APPLICATION NO.	FILING DATE	FIRST NAMED INVENTOR	ATTORNEY DOCKET NO.	CONFIRMATION NO.
10/581,958	09/20/2006	Poul Erik Jespersen	PATRADE	8746
James C. Wray	7590 02/10/200	EXAMINER		
1493 Chain Brid Suite 300	dge Road	SCRUGGS, ROBERT J		
McLean, VA 22101		ART UNIT	PAPER NUMBER	
			3723	
			MAIL DATE	DELIVERY MODE
			02/10/2009	PAPER

DETAILED ACTION

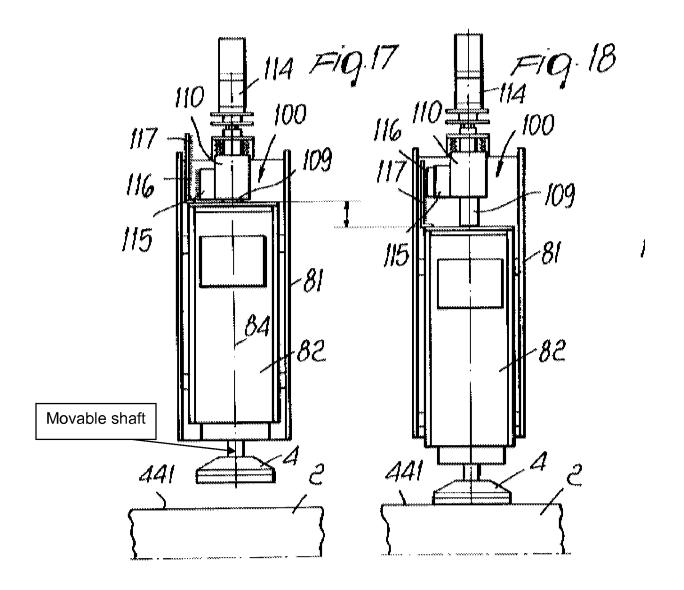
In reference to claim 4, Rosa also teaches of providing a movable shaft (see figure below) connected to the grinding motors.
